BID Meeting - Plan Updates

Summary Document
05-07-2026

CONFLUENCE

ITEM #1 - STATIONS 7, 8

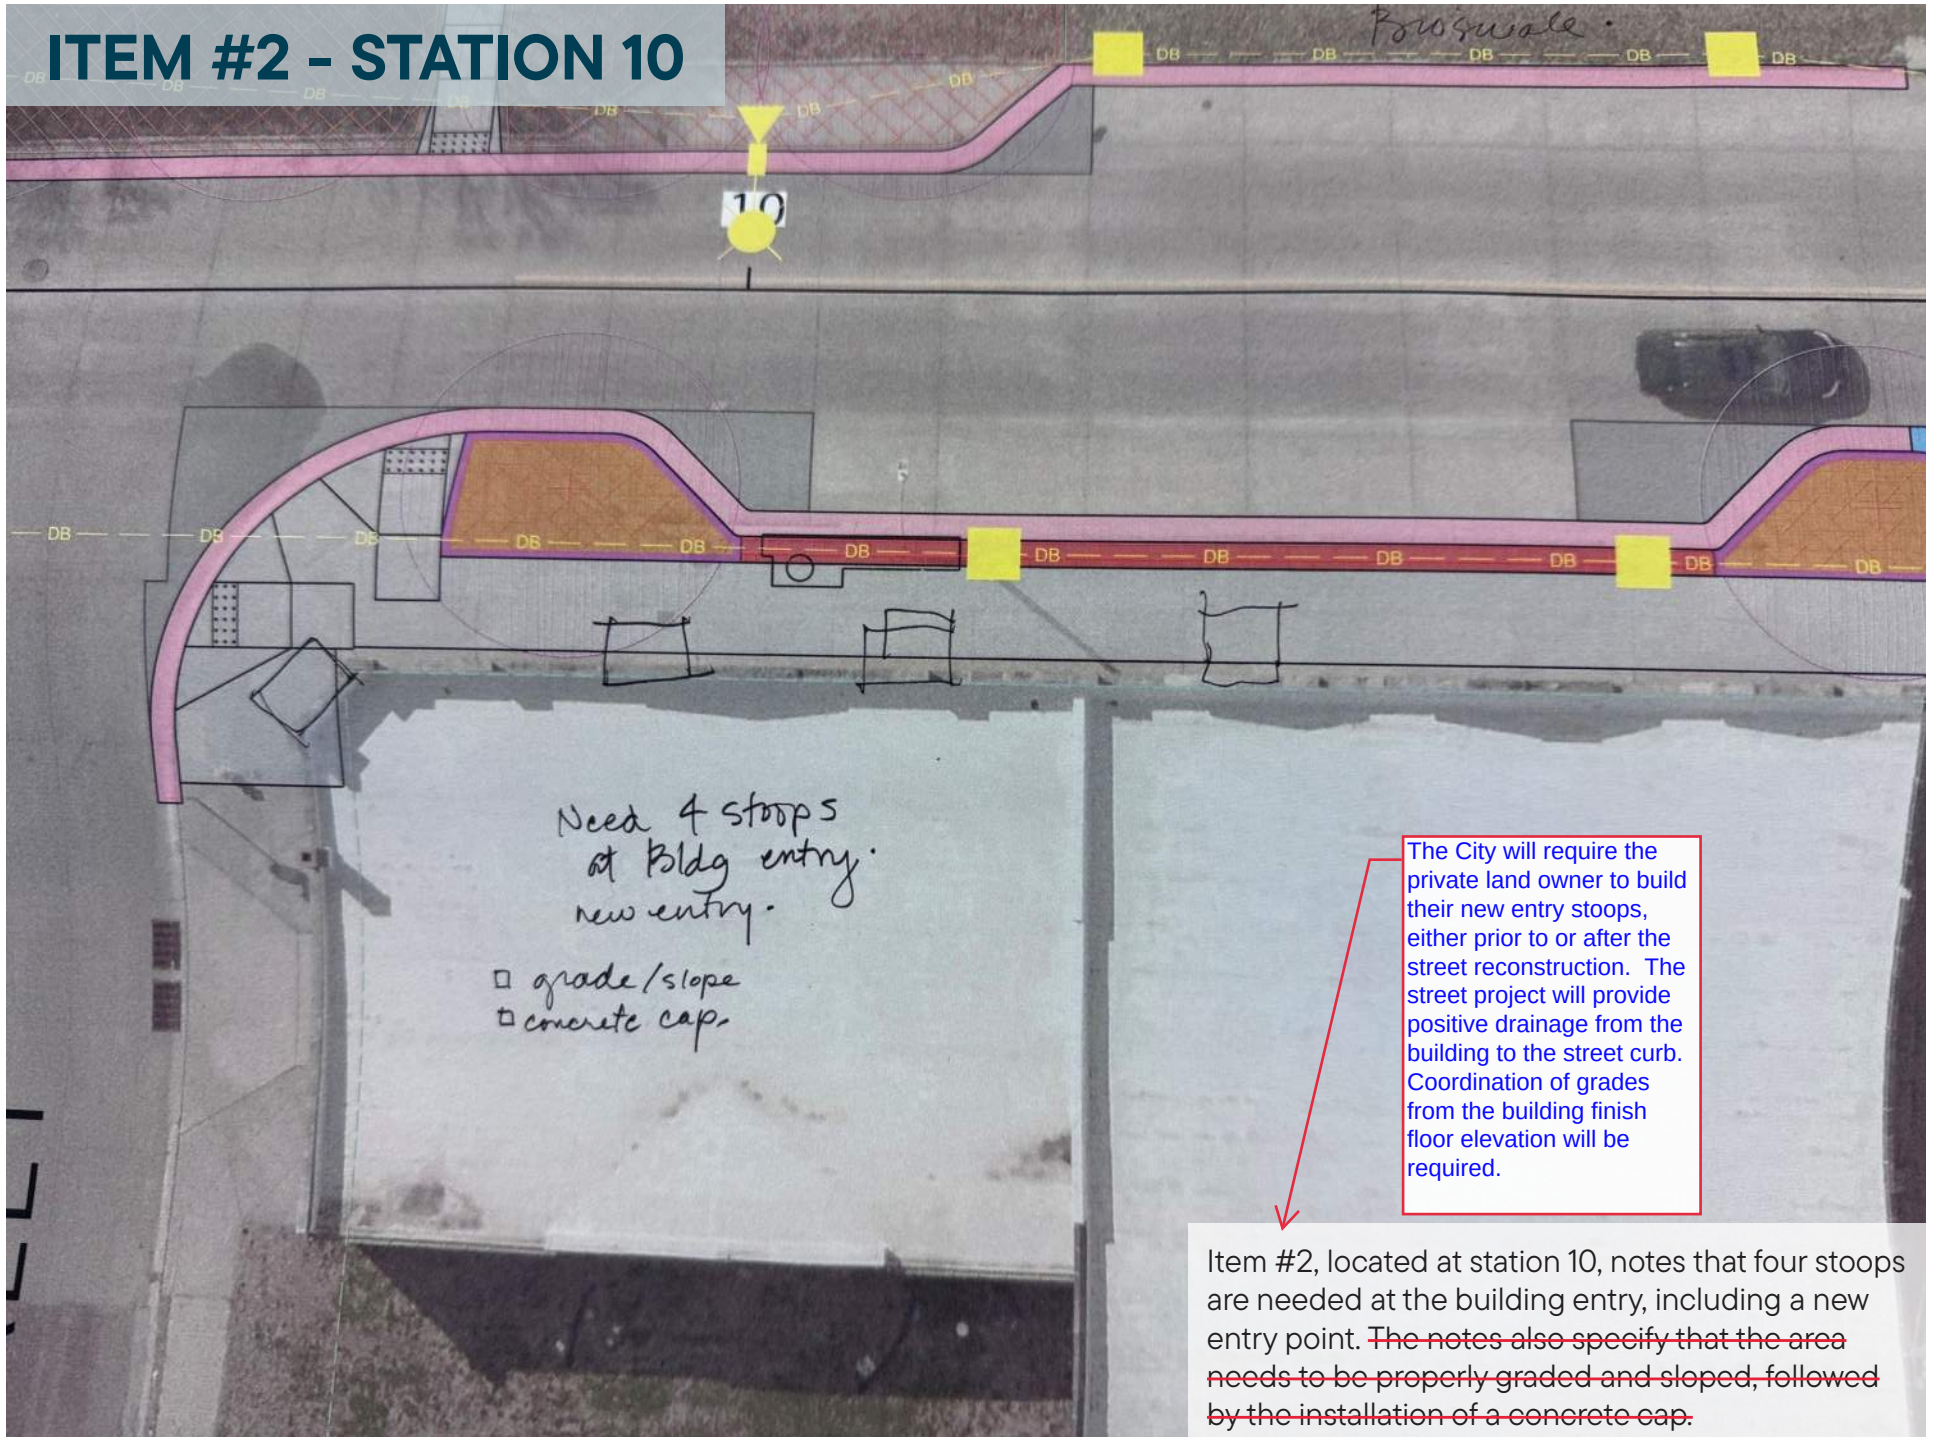
Can this project build this portion and land owner not. TIF w/ Parking.

On This R... parking lot. ing site.

outdoor pavilion July 2026 const. start, Brownfield.

Item #1, located between stations 7 and 8, states that the property owner has clarified that the designated area will be used as a parking lot rather than a building site. Plans are also in place to construct an outdoor pavilion on the property, with a projected start date of July 2026. The site is currently classified as a brownfield. ~~The project, ideally, should build the dashed portion on the Plan without TIF funding, rather than having the land owner take responsibility.~~

The City will require the owner and the private project to realign the curb and build out to the design, since the private project is using TIF funding.

ITEM #3.1 - STATIONS 24, 25

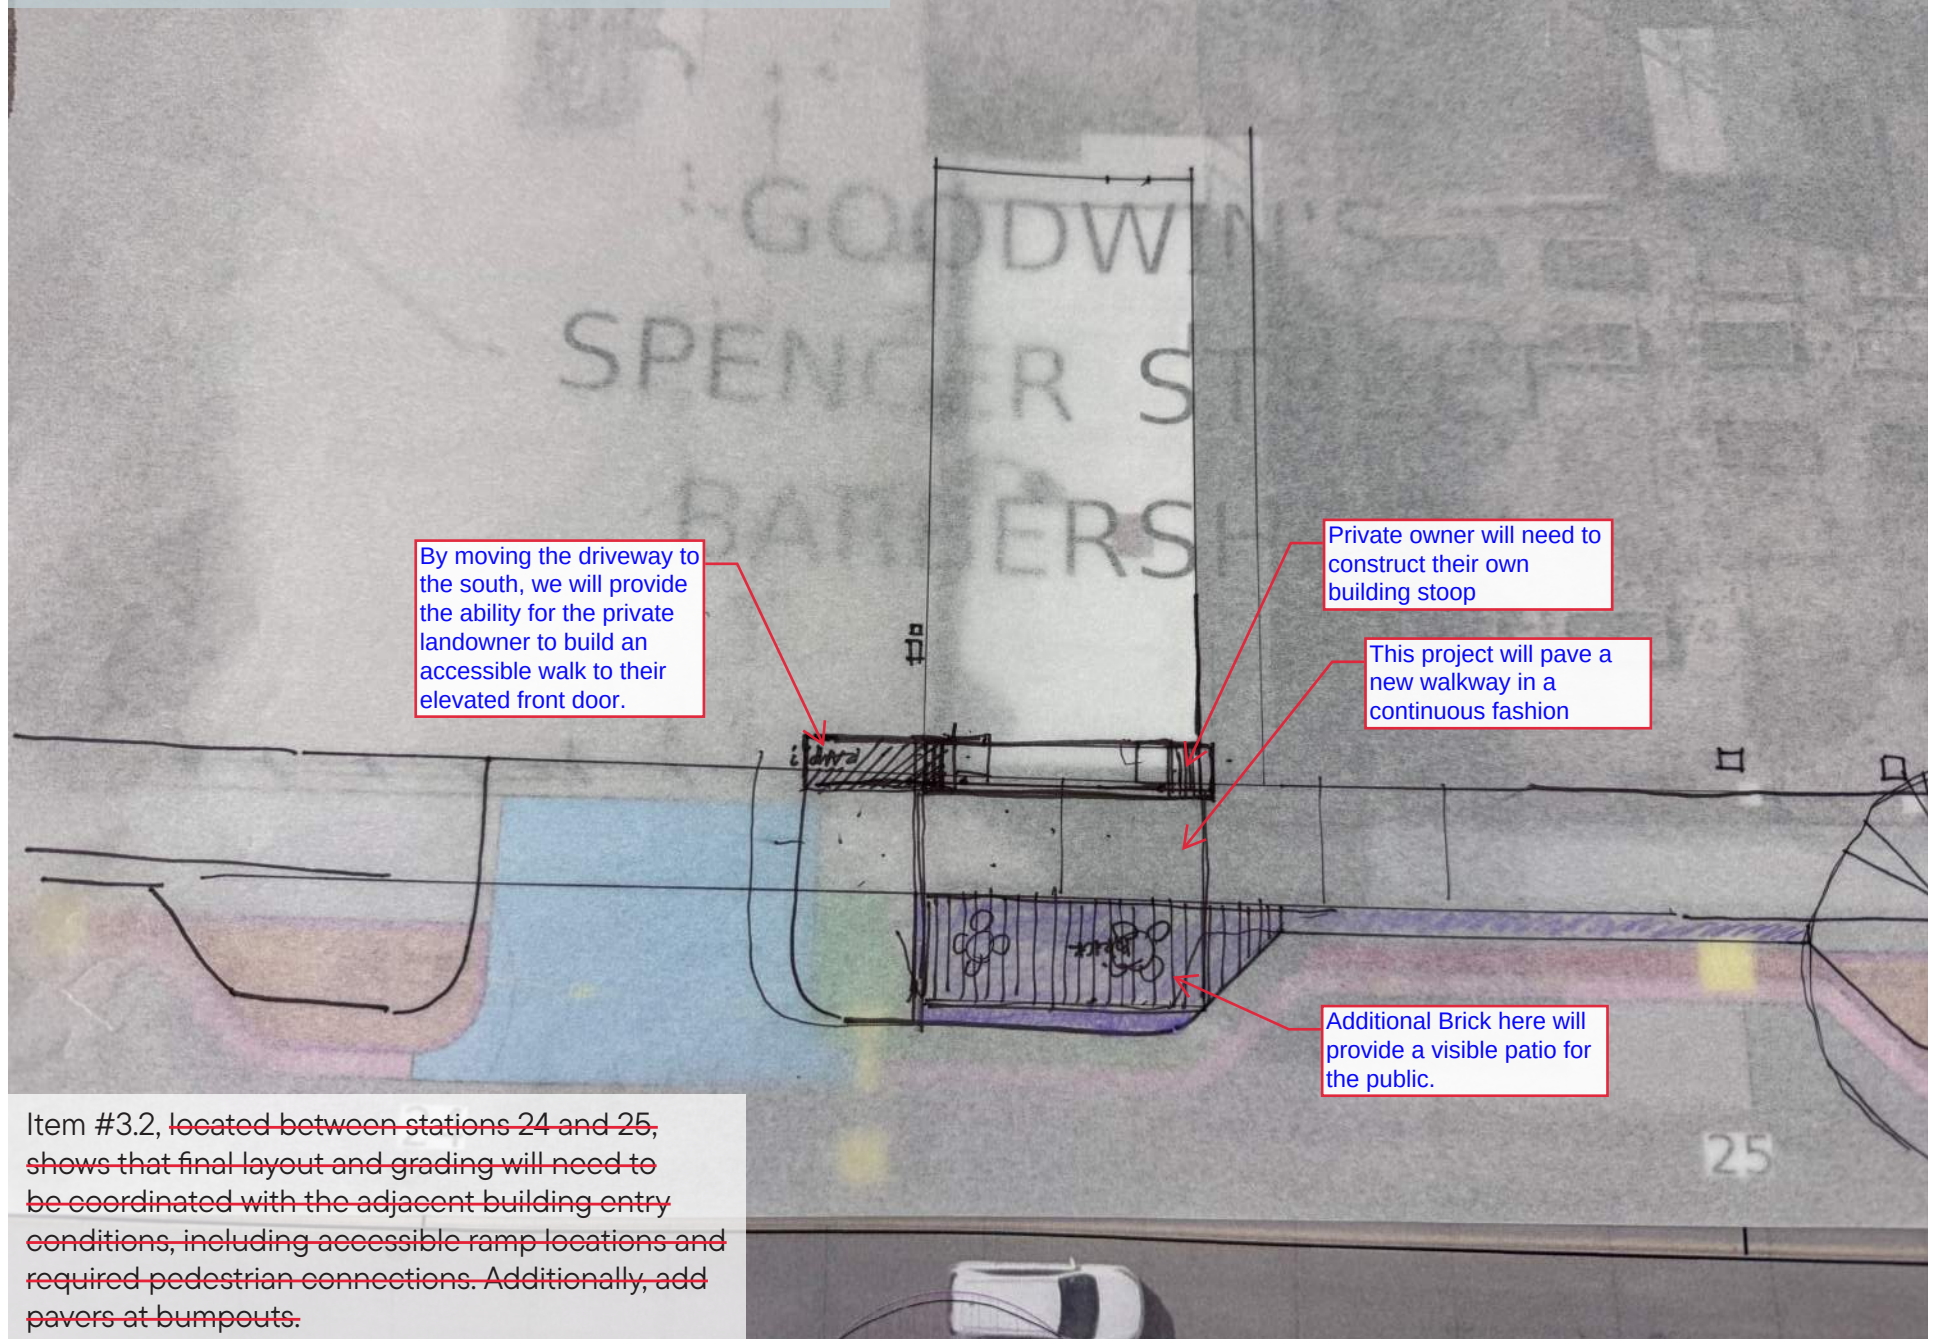
Move the driveway further south to allow the full dimension of a 90 degree parking area.

Item #3.1, located between stations 24 and 25, identifies the need for additional paved street access, as well as a widened sidewalk. Further notes can be found on the next page.

ITEM #4 - STATIONS 25, 26

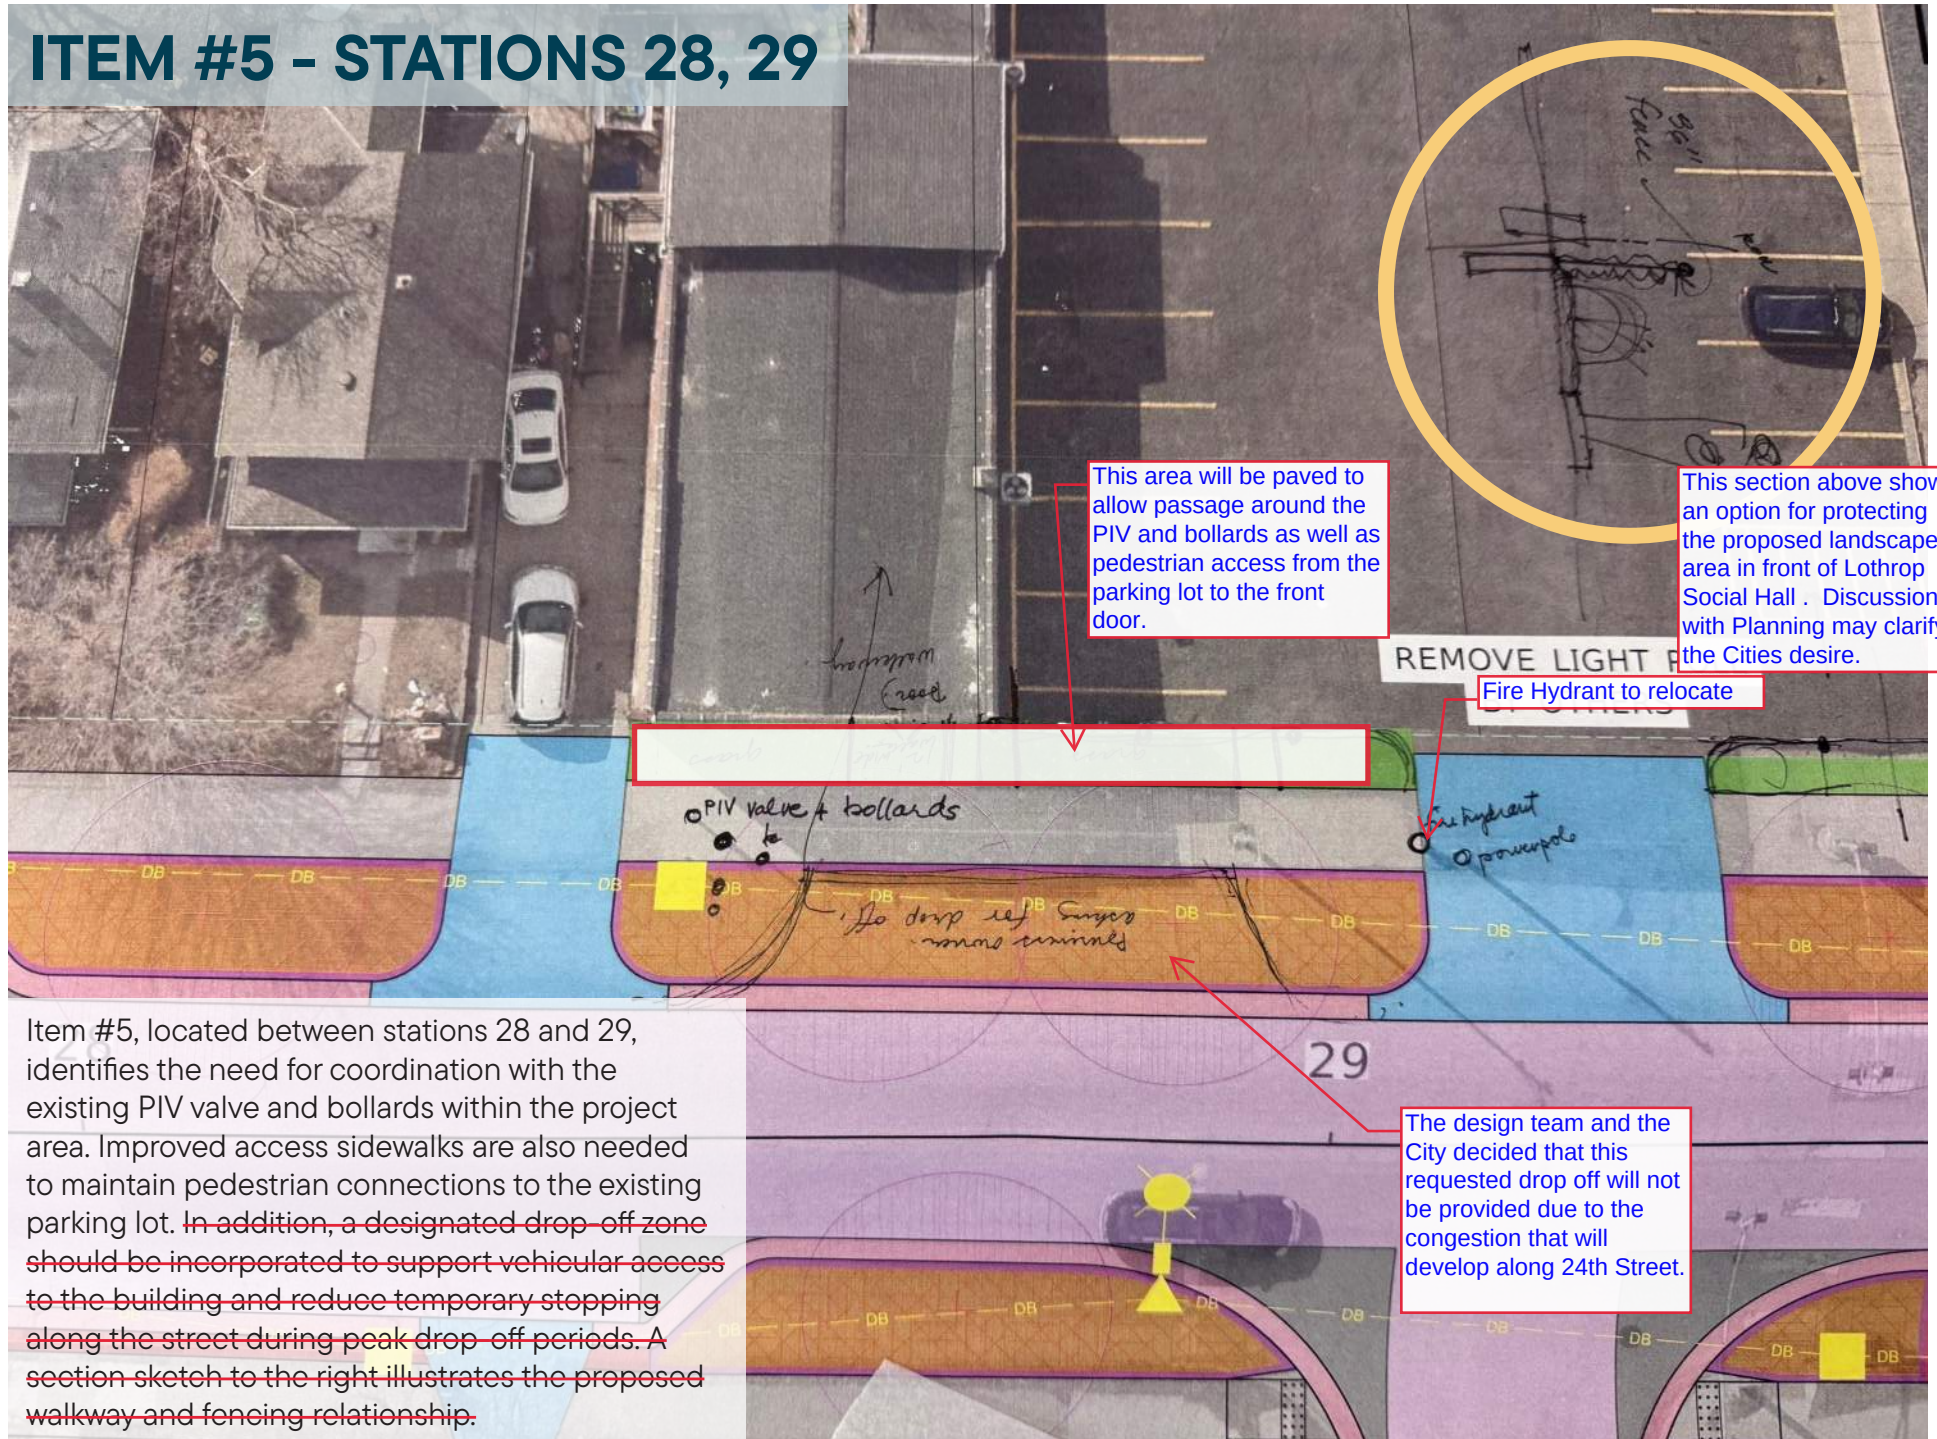
she would like more parking.

owner is glad the bus stop will not be here.

can we add a tree?

Item #4, located between stations 25 and 26, highlights that the owner is pleased that there will be no bus stop at the site, however, she would like to see more parking reflected in the final Plan. Additional trees should also be integrated along Spencer and N24th Streets, in identified locations.

Design team agreed that additional parking was difficult to accomplish and would not be provided.

ITEM #5 - STATIONS 28, 29

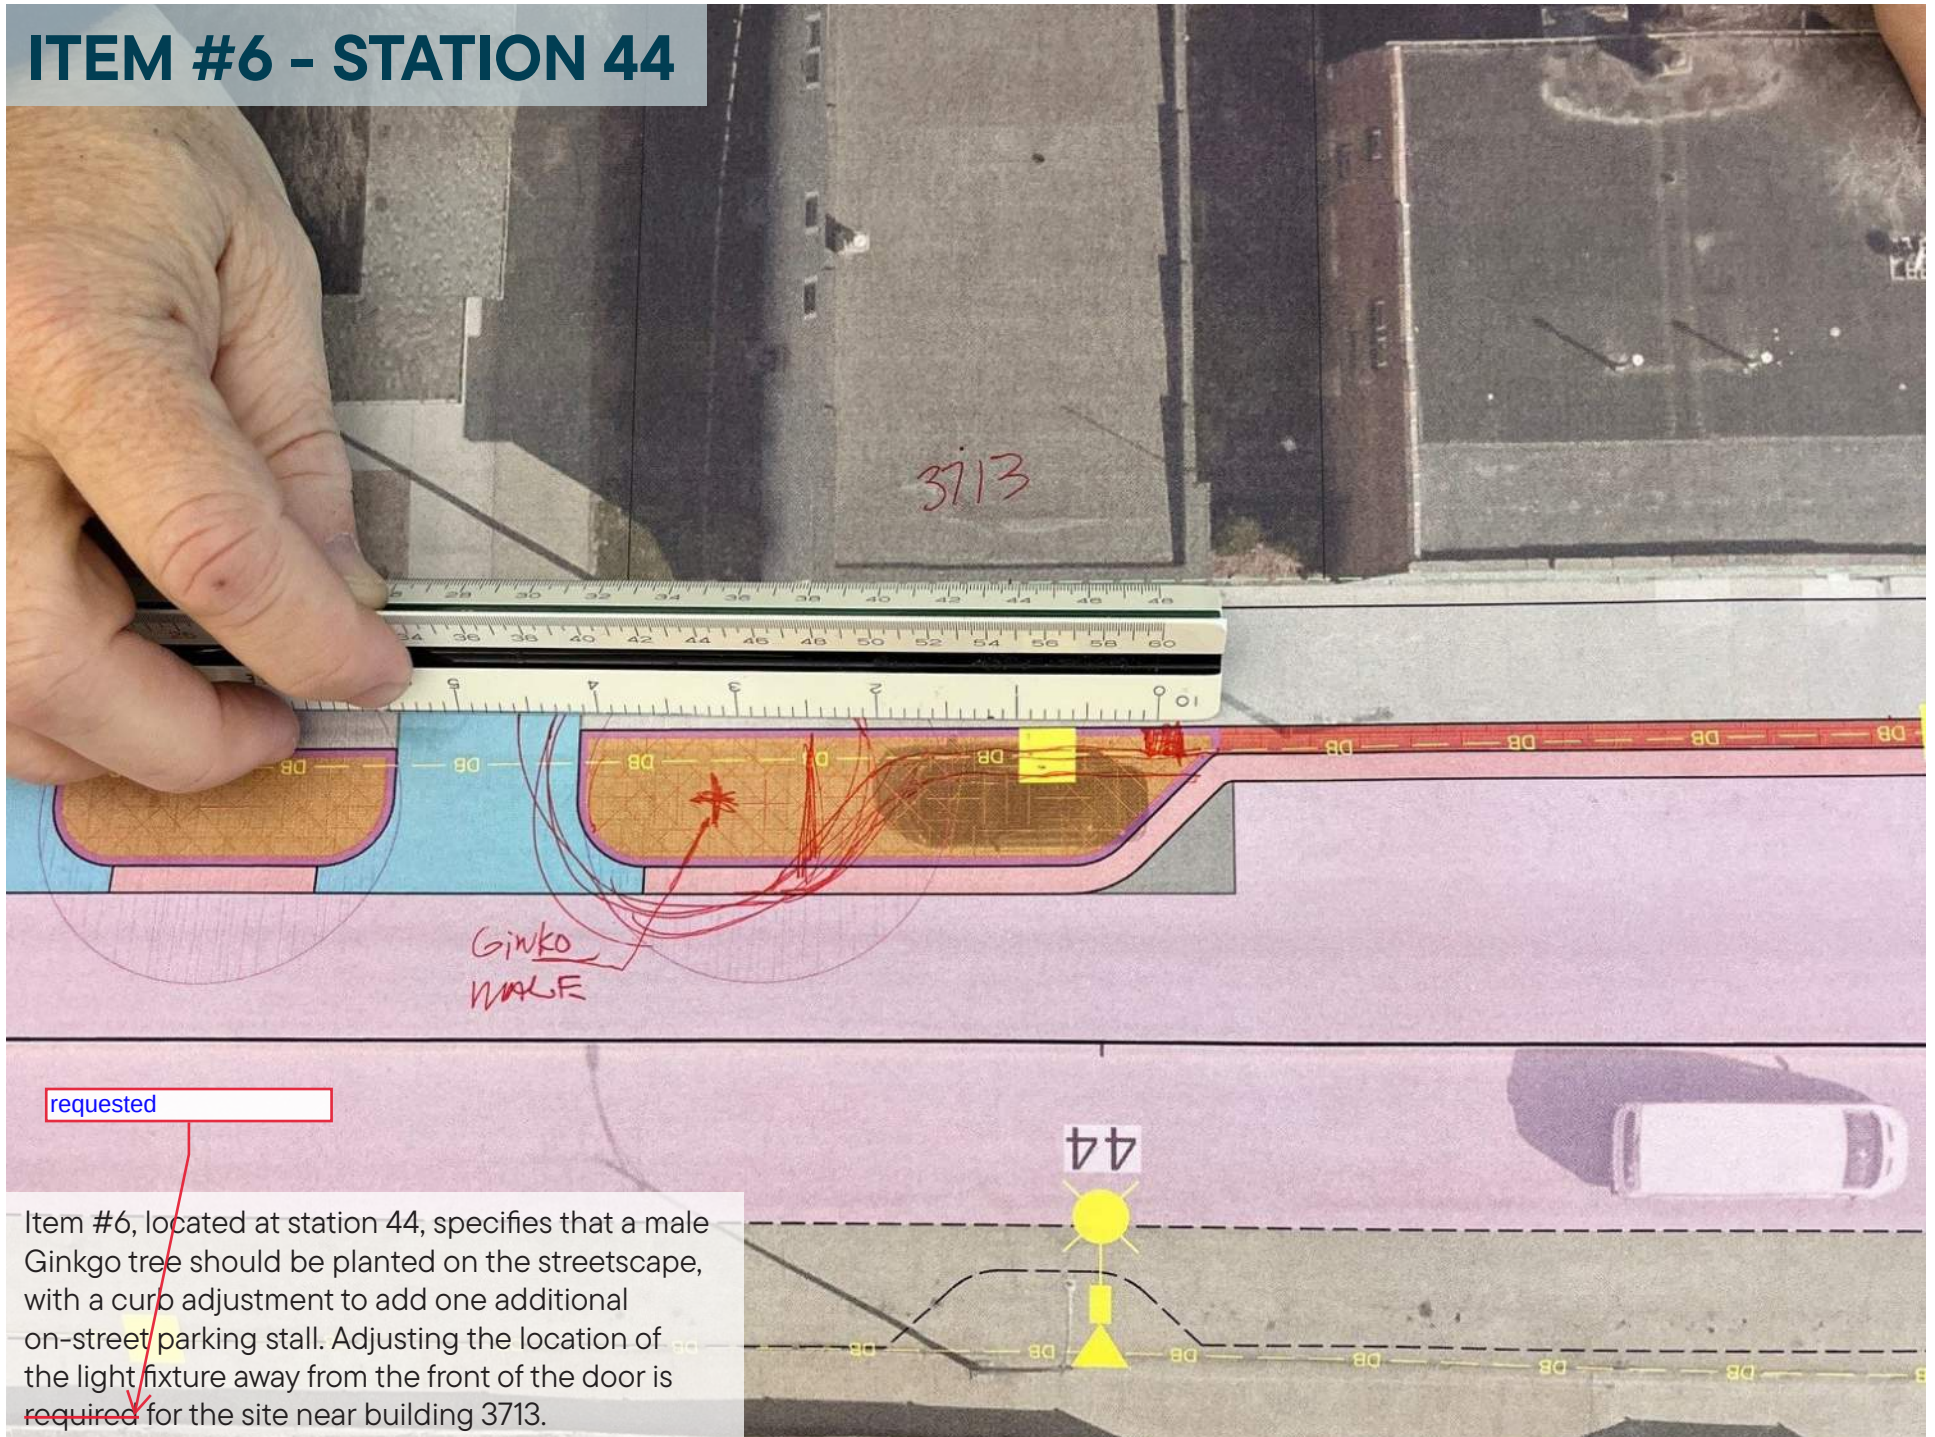
Item #5, located between stations 28 and 29, identifies the need for coordination with the existing PIV valve and bollards within the project area. Improved access sidewalks are also needed to maintain pedestrian connections to the existing parking lot. ~~In addition, a designated drop off zone should be incorporated to support vehicular access to the building and reduce temporary stopping along the street during peak drop off periods. A section sketch to the right illustrates the proposed walkway and fencing relationship.~~
